Your Ref: MP 06_0094 MOD 5

RE: High Dune Pty Limited | Modification to Sandon Point Concept Approval MP 06_0094 MOD 5

RE: High Dune Pty Limited | Modification to Sandon Point Concept Approval MP 06_0094 MOD 5

Figure 2 – Location of 'Sturdee Ave OC1' (sourced from Fig 21 of MDCA ACHAR dated Nov 2018)
Footnote to MDCA Fig 21 states, 'Purple shading is the extent of Sturdee Ave OC1. The green outline depicts the densest and most significant portion of Sturdee Ave OC1, which is to be preserved'

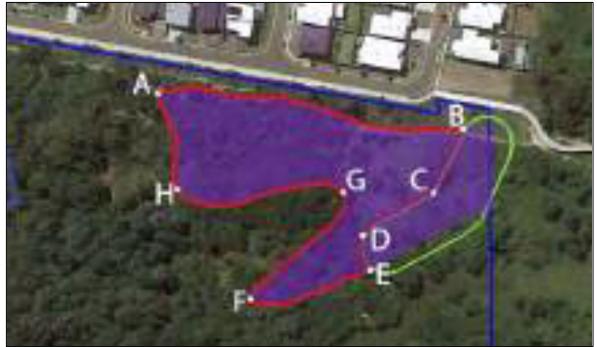
5. The most significant portion of Sturdee Ave OC1 is the eastern part, as shown in **Figure 2** below.

- 11. The JSA Studio drawing used for Figure 20 in the Department's Mod 5 Assessment report incorrectly indicates the 'Aboriginal Archaeological Zone' to extend under the existing Wilkies Street road embankment. This looks to derive from a misinterpretation of MDCA Figure 21 titled 'The detail of the area proposed to be covered by an AHIP' (see Figure 1 above). This figure shows the extent of Sturdee Ave OC1, this time by purple shading, and covers the same area delineated with orange/brown shading on MDCA Figure 19 (Figure 2 above).

- 12. The caption of MDCA Figure 21 explains that 'the green outline depicts the densest and most significant portion of Sturdee Ave OC1, which is to be preserved'. The green outline however is shown in a diagrammatic sense, being drawn using a boomerang shape, and as a result notionally covers additional areas that are not part of Sturdee Ave OC1. It is clear however that the green 'boomerang' outline does not mean that the extents of Sturdee Ave OC1 as shown in orange/brown on Figure 19 and in purple on Figure 21 are incorrect. Its purpose is just to highlight that portion of Sturdee Ave OC1 that is the most significant, and is not to intended to modify/extend Sturdee Ave OC1 (which would also serve to make Figure 19 invalid and contradict the statement in section 6.1 as quoted above, which is clearly not the intent).

- 15. The Department's assessment report appears to suggest that the green overlay on MDCA's Figure 21 (reproduced above at Figure 2), redefines the boundaries of the culturally significant area, so as to extend it in an easterly direction.
- 16. To the contrary, the green overlay is designed to highlight an area in which a higher density of artefacts was discovered, rather than redefine the boundaries of the mapping for the documented extent of artefacts.
- 17. I apologise for the successive submissions on this matter. However, it is considered that with the benefit of this final commentary, the Department has all the necessary information to properly determine Mod 5 and apply appropriate conditions.

Figure 3 – Extract from Cardno Drawing SK09 as referred to in MP07_002 Approval Condition A3 (with as-constructed information superimposed)

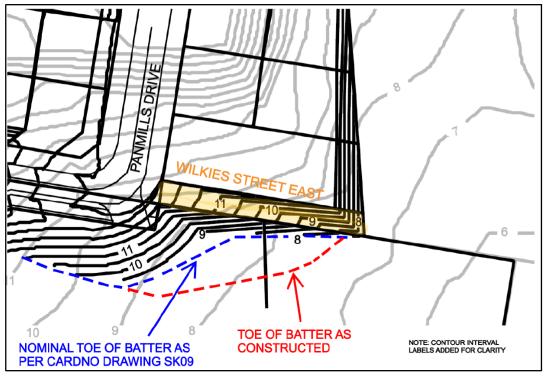
6. Ironically, previous impacts to the area immediately north of the most sensitive part of Sturdee Ave OC1 derive from previous planning decisions made by Wollongong City Council. The Major Project No. 07_0032 Approval restricted bulk earthworks in the immediate vicinity of Sturdee Ave OC1 as shown in **Figure 3** below, which is extracted from Cardno drawing number SK09 'Preliminary Bulk Earthworks Plan' which is referred to in the Major Project No. 07_0032 Approval Condition A3.

- 7. **Figure 3** shows the toe of batter of the Wilkies Street East road embankment as originally intended under the Major Project approval in blue and as subsequently approved by Council in red. It is not known whether the more extensive embankment footprint resulted in damage to aboriginal artefacts on the northern periphery of Sturdee Ave OC1. The MDCA Nov 2018 ACHAR prepared for the Anglicare site (section 6.1) however states in discussion of Sturdee Ave OC1 that, 'The site is highly unlikely to extend further north over the current alignment of the unsealed pedestrian track known as Wilkies Walk. The area to the north of the track has been heavily disturbed by bulk earthworks associated with the construction of Wilkies Street'.

- 9. It is highly unlikely therefore that that Aboriginal cultural heritage area near Wilkies Walk extends under the existing Wilkies Street road embankment given the pre-existing topsoil and subsoil layers underneath the embankment (which would have contained any artefacts present) were removed by heavy earthmoving equipment during construction of the embankment. We also note at the time the road embankment was constructed in 2014, Wollongong City Council heritage officer confirmed such a view. Reference is made to an email from Council's heritage officer to Susan Mcintyre-Tamwoy of AHMS (now Extent Heritage) dated 26 November 2014 stating, 'As there are no "Relics" in the location of the works, there is no trigger for any requirements for an excavation permit under the NSW Heritage Act 1977 and it would therefore not be possible to obtain such a permit from the NSW Heritage Office (Branch).'
